NUCLEAR ENERGY INSTITUTE

SUBJECT: Generic Aging Lessons Learned Report Comments

PROJECT NUMBER: 690

A3. Spent Fuel Pool Cooling and Cleanup (Pressurized Water Reactor)

VII C1-2

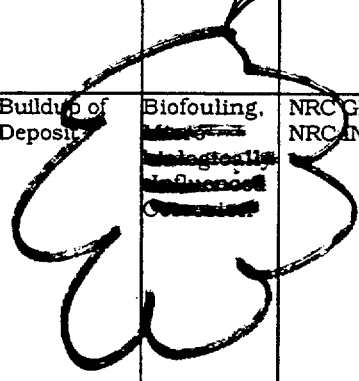
INSERT 12
(SEE CHAPTER
#11 FOR
OPEN CYCLE
COOLING WATER
SYSTEM INSPECT
GL 89-13

SEE CHAPTER 11 FOR EVALUATION AND TECHNICAL BASIS FOR THE OPEN CYCLE COOLING WATER SYSTEM INSPECTIONS (GL-89-13).
